Re: Site Plan Control Application
File Number: D07-12-22-0094– 78 Rosemount Avenue

In response to your comments dated August 11th, 2022, I am providing the following information:

78 ROSEMOUNT AVE.

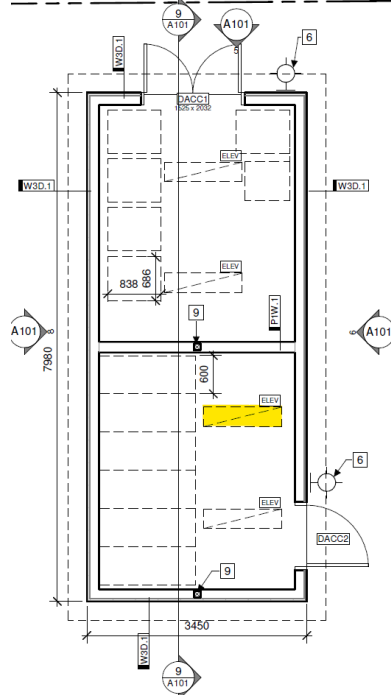
4. The dashed box in the plan is a light fixture (above).

Please see image below for clarification:

1 SITE PLAN
 A100 1:100

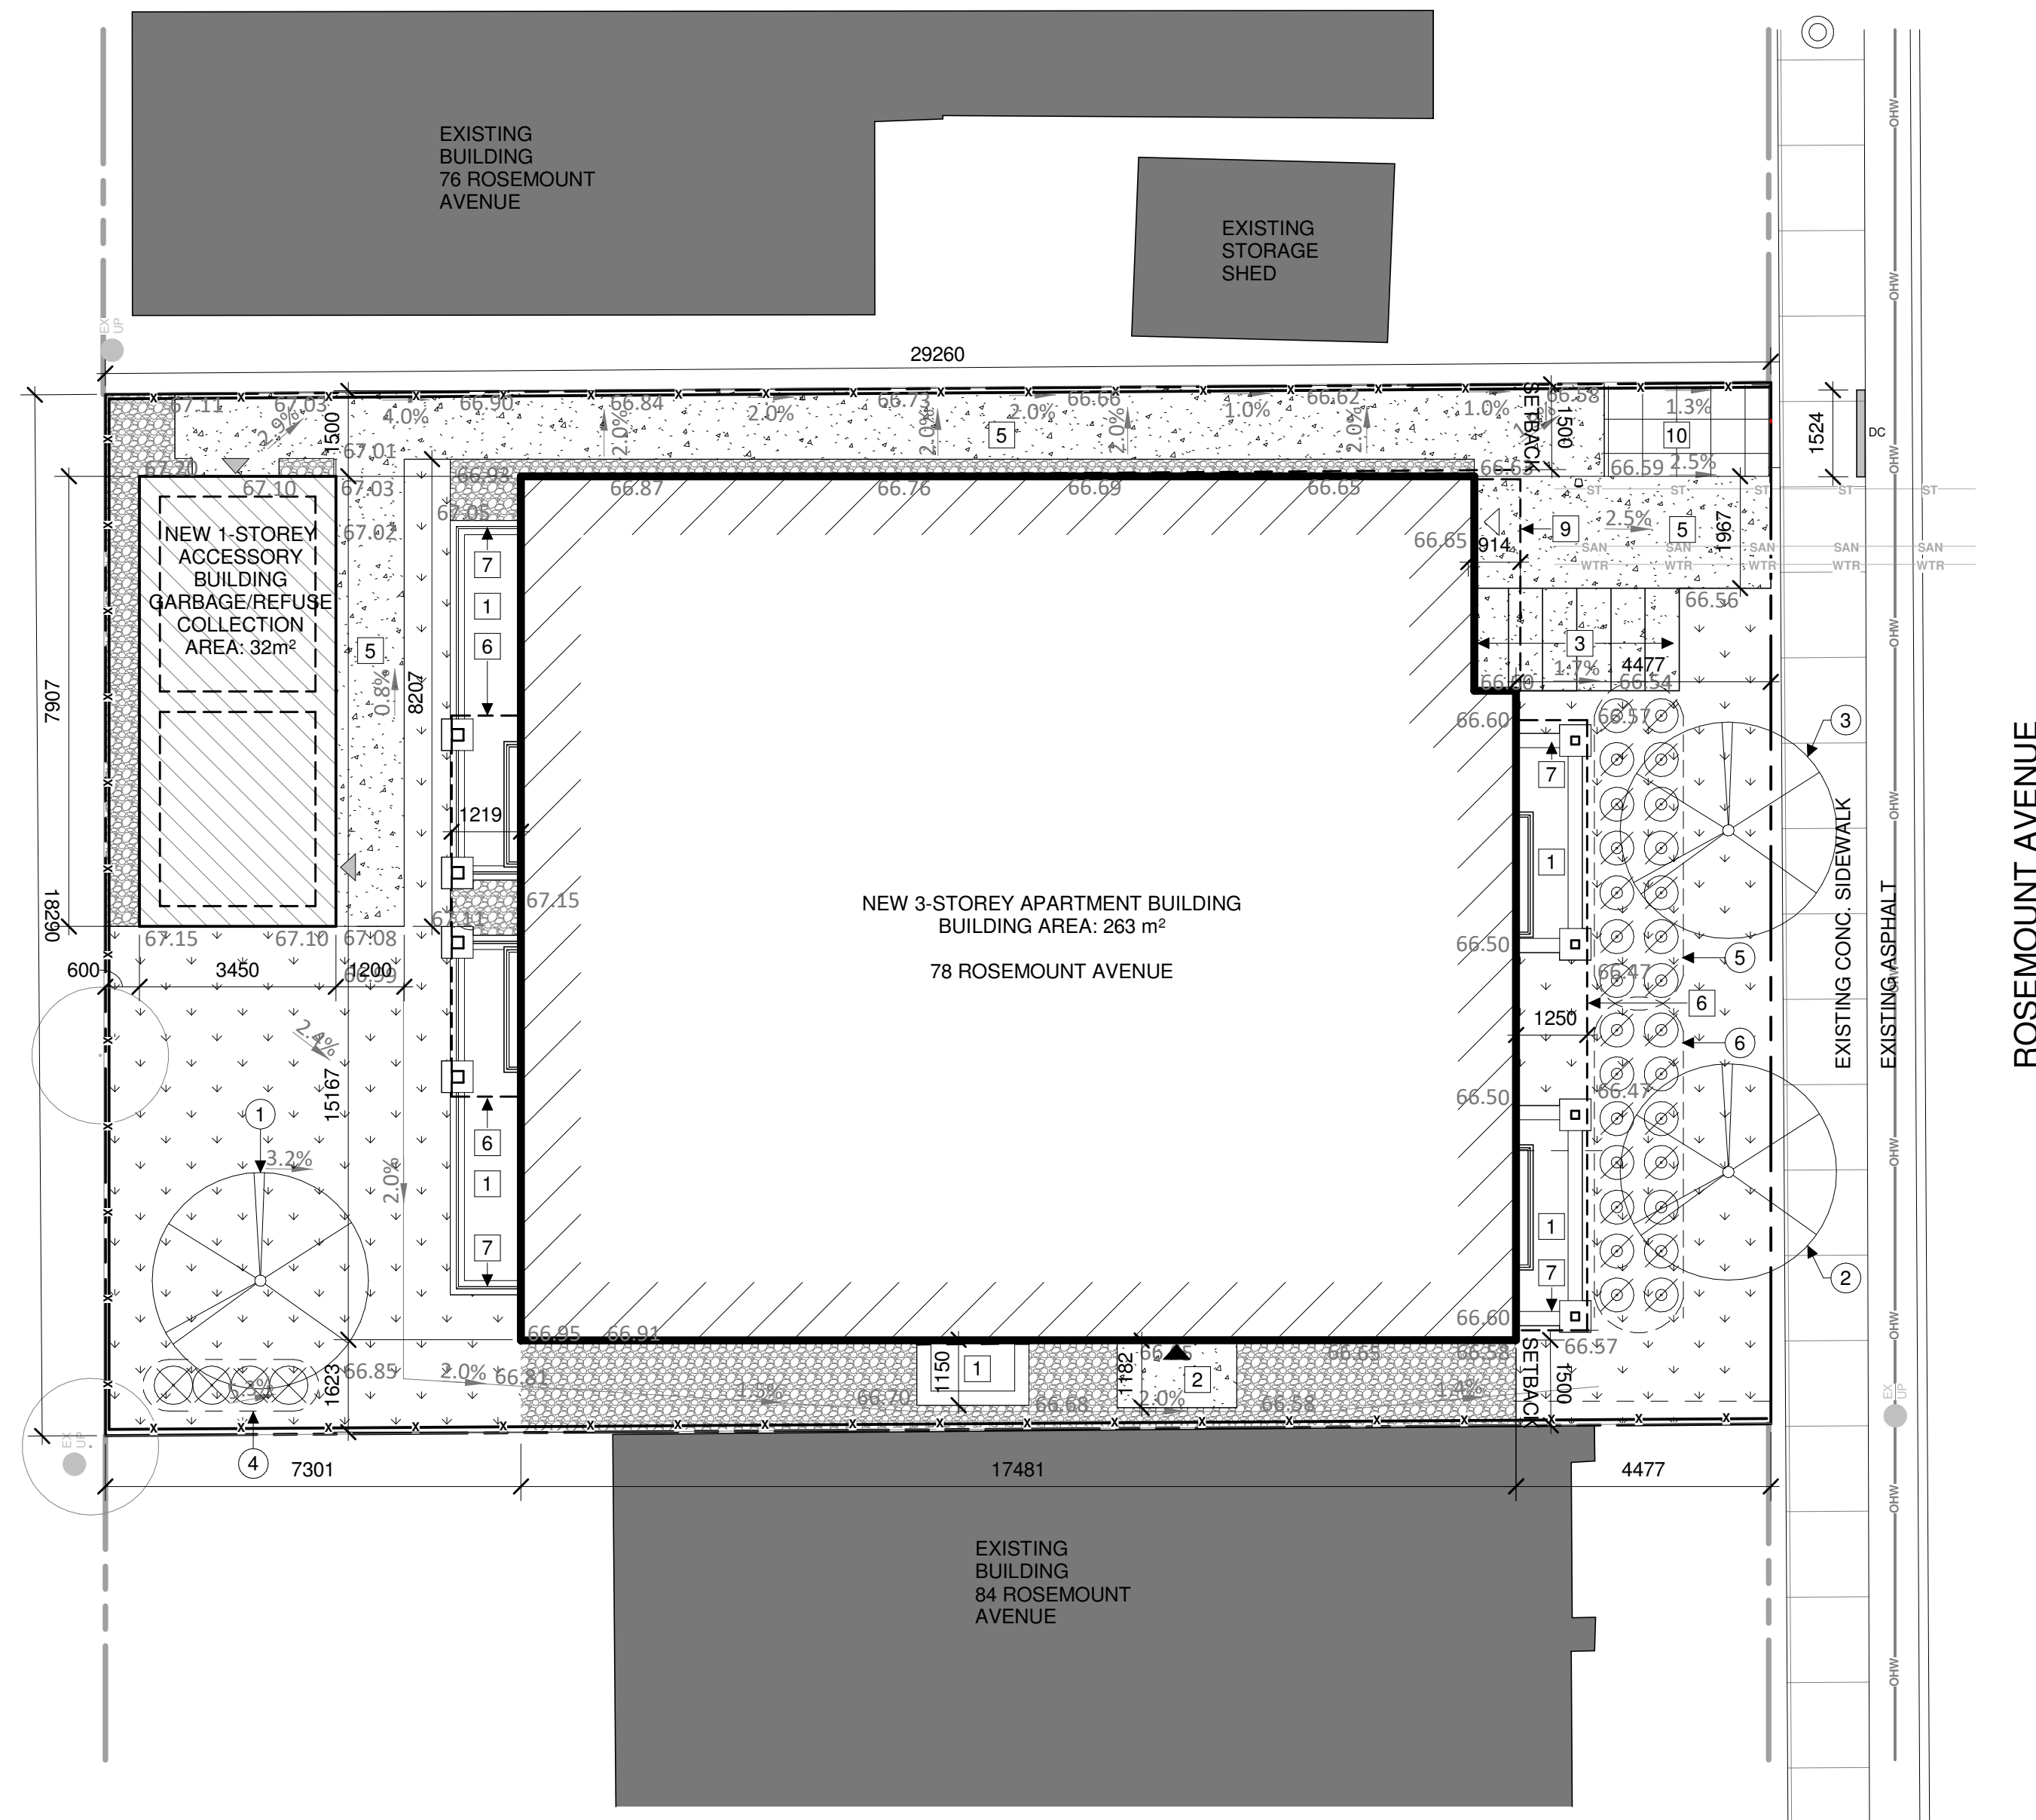
5. Noted. Please see attached A100.

42. The reference survey is included on A100.

52.1.a. Noted. A survey of the medium voltage hydro wire location was completed. The proposed building location has been moved back so that it does not fall within the "restricted zone" surrounding overhead lines.

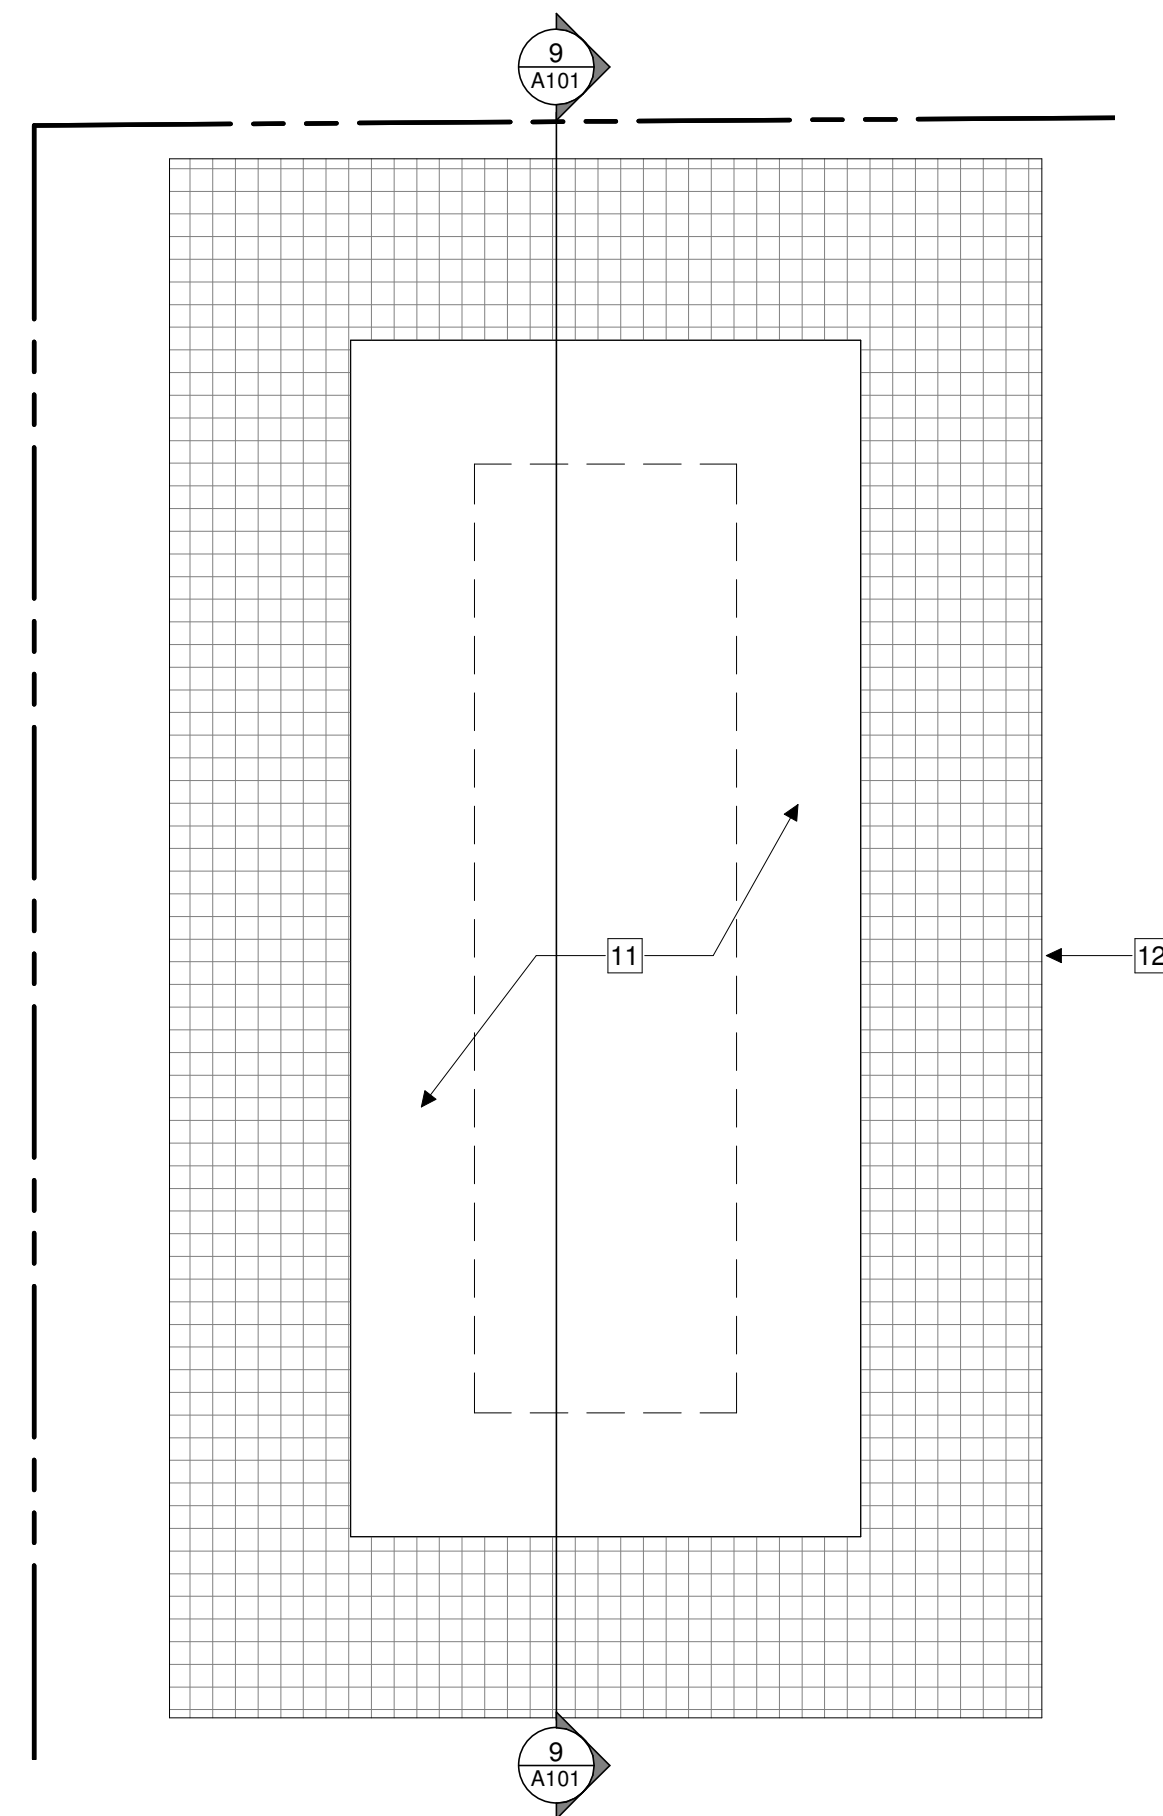
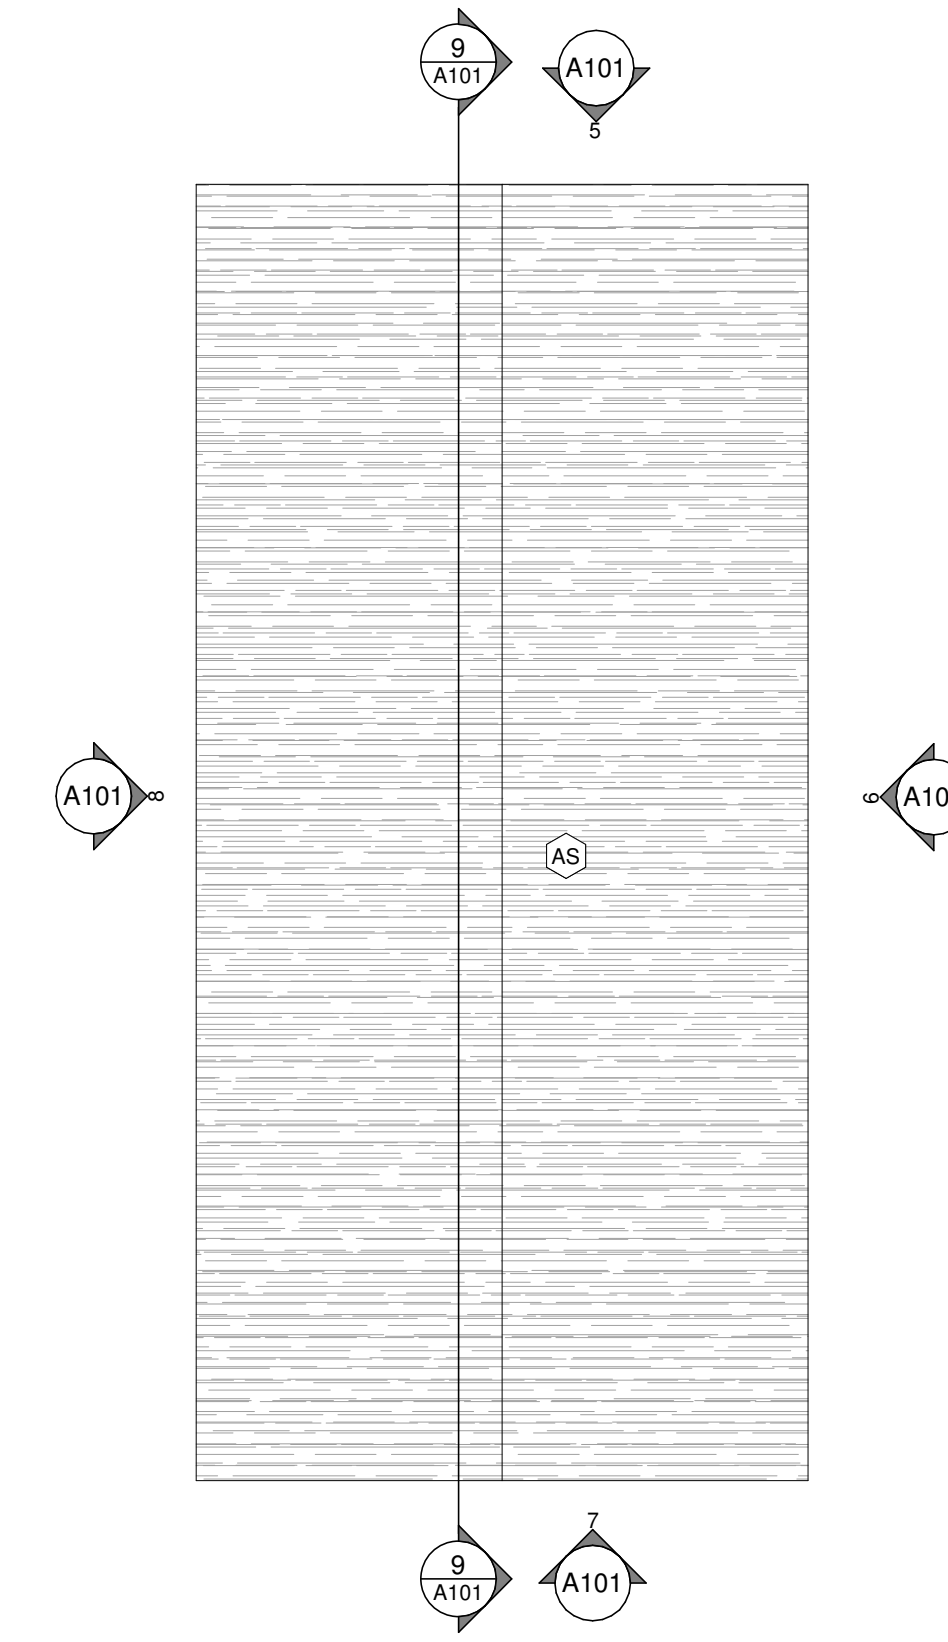
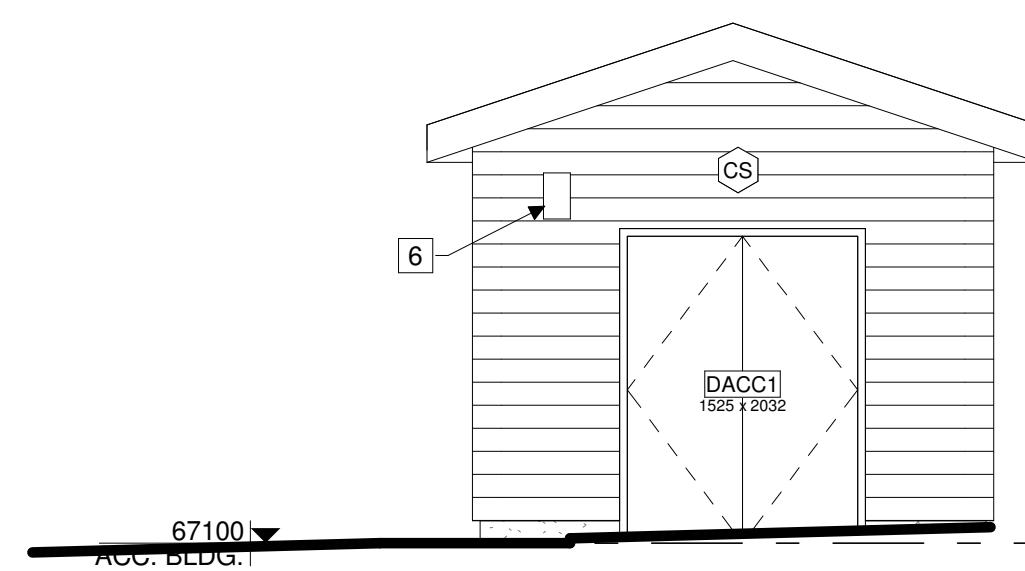
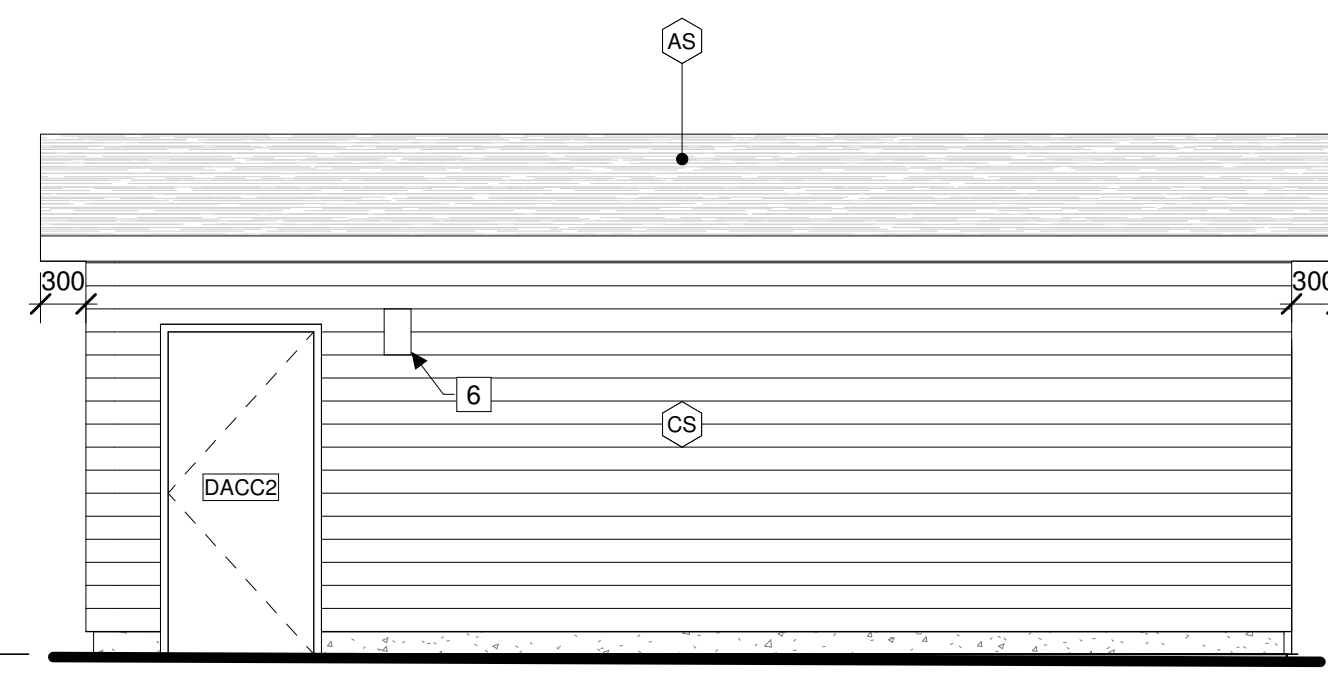
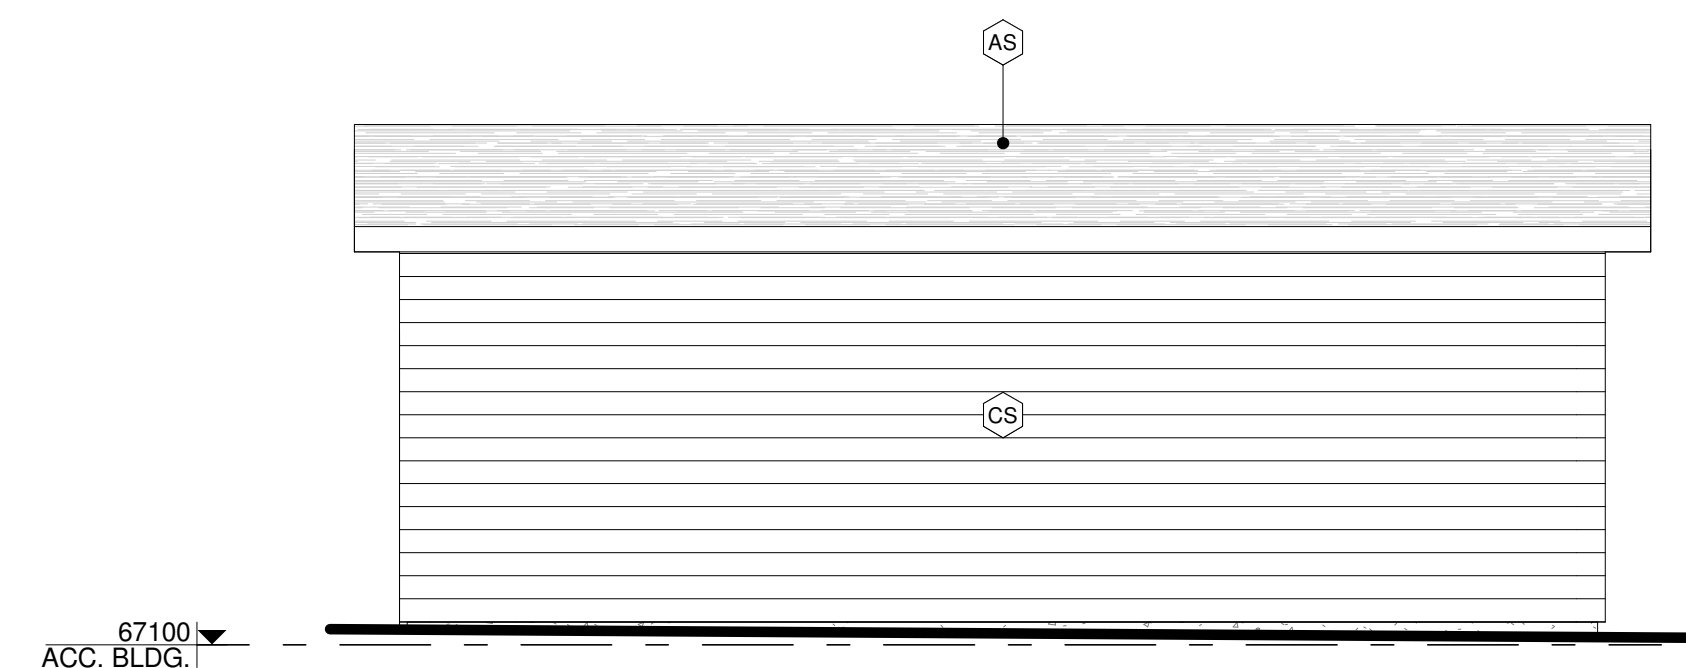
43. Noted. Please see attached A101.

44. Noted, a set of double doors has been indicated on revised drawing A101.
